SERVICE BULLETIN 32

SUBJECT: GLASAIR III ENGINE MOUNT AND FIREWALL TEMPLATE.

APPLICATION: Glasair III kits; S/N 3001 thru 3009
S/N 3011 thru 3014

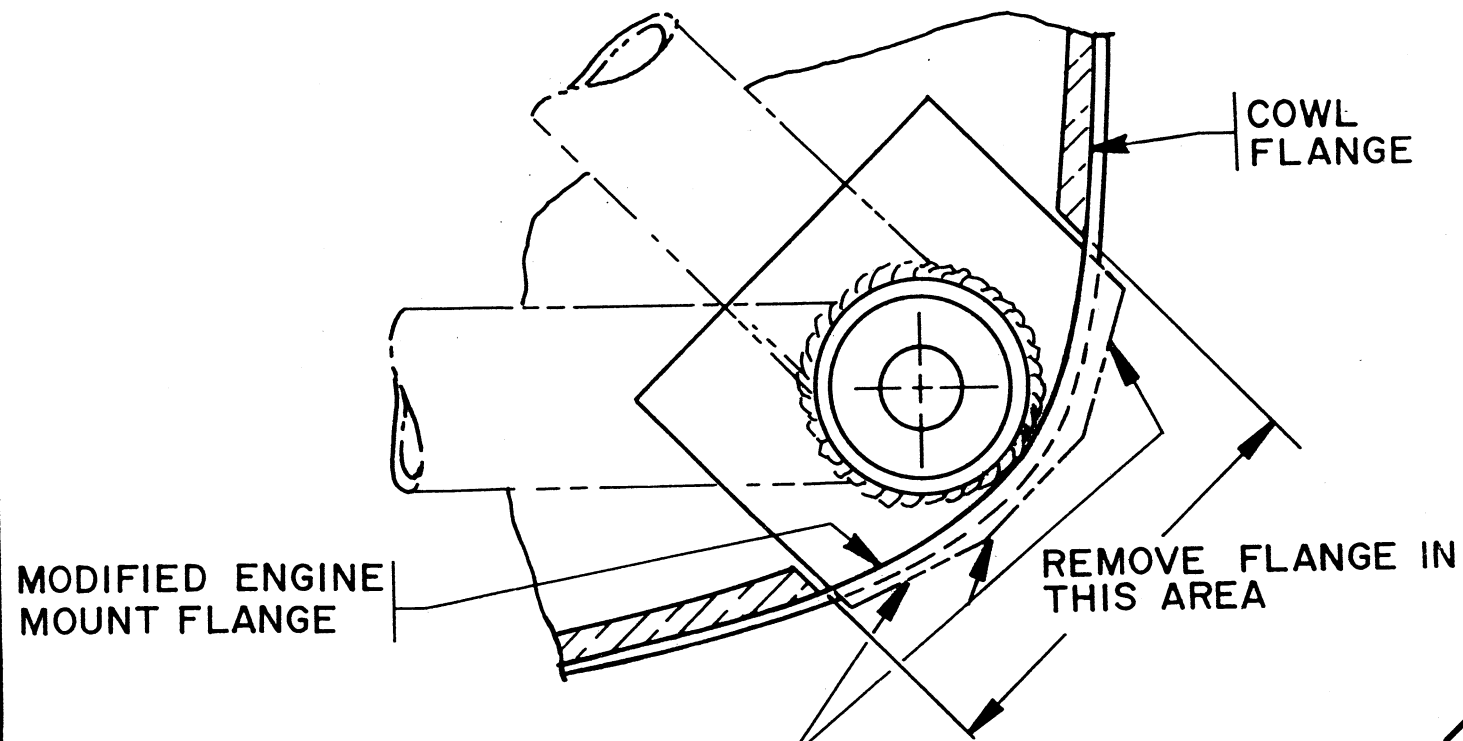
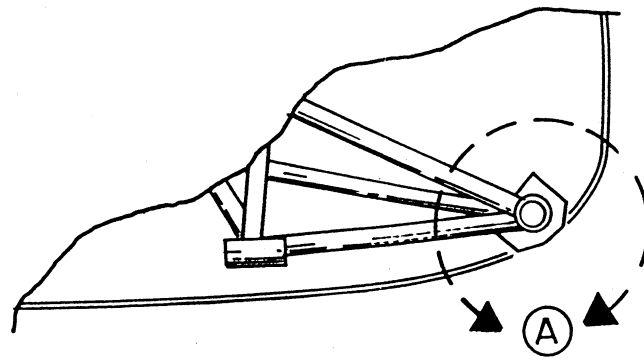
With the original style engine mounts, the fiberglass cowl flanges must be locally trimmed back flush with the firewall or slotted to provide clearance, yet even with this modification, it is possible that the engine mount lower corner flange will still interfere with the engine cowling itself.

In addition a slight interference may exist between the lower corner engine mount tube and the lower cowling. The lower cowling slopes upward from the firewall and the engine mount tube extends straight forward. These tubes may also be ground for proper clearance when the lower cowling is fit to the aircraft.

Please Note: This is not a mandatory Service Bulletin. If the engine mount will fit without engine mount base plate to cowling interference, by grinding the base plates back and trimming the fuselage cowling flanges, it will be both structurally and cosmetically acceptable.

Locate the center of the two upper engine mount bolt holes 5.25" above Waterline 100. It will be necessary to grind back the steel base plate of the engine mount attach points to allow them to fit. It is permissible to grind the base plate back to the base of the weld. Level the engine mount laterally at the nose gear trunion attach points following the instructions given in Service Bulletin 22.

If the engine mount reinforcement laminates on the aft side of the firewall have been completed, there will still be adequate space for the nuts on the aft side of the engine mount bolts. At this point the engine mount holes can be drilled using the mount as a drilling jig as stated in the Instruction Manual.

FIGURE (1)

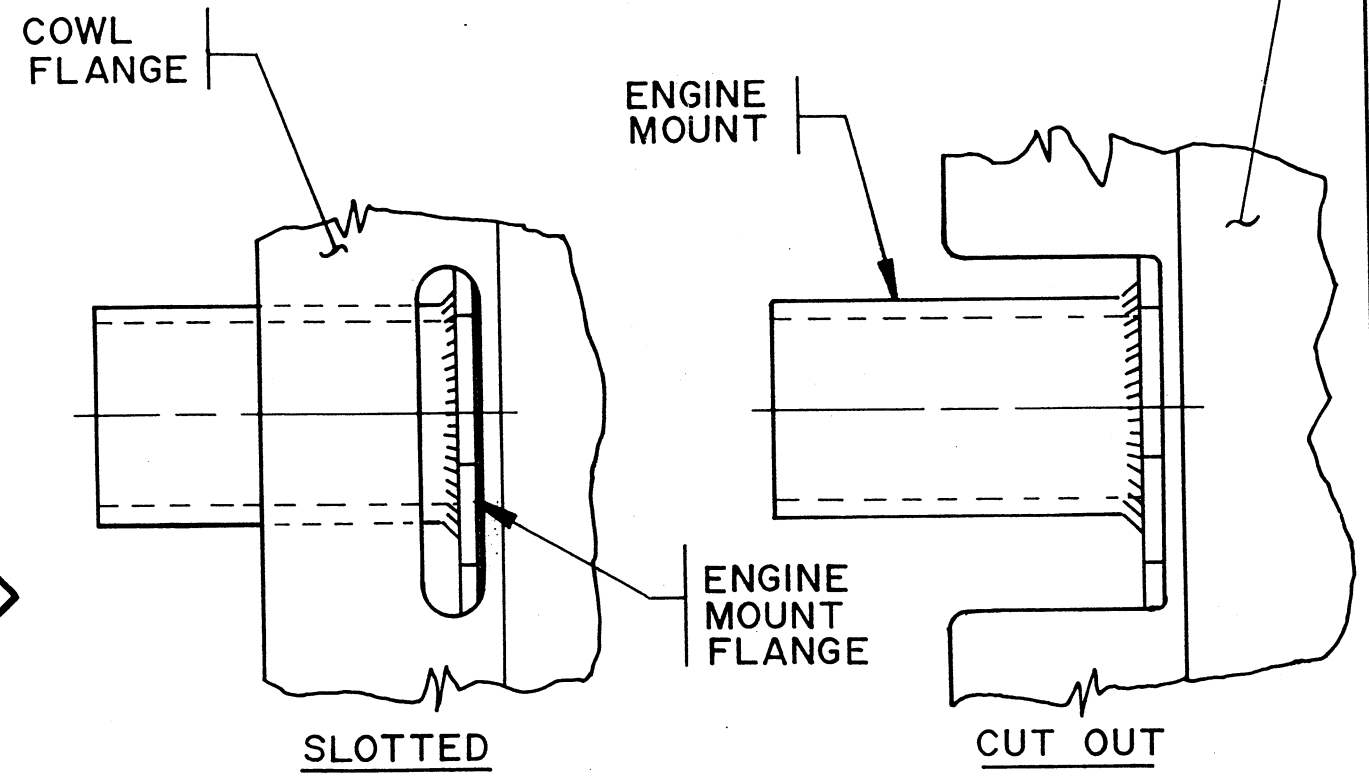
TRIM ENGINE MOUNT
FLANGE TO MATCH
COWL FLANGE

VIEW B-B
(LOOKING IN 'BD.)
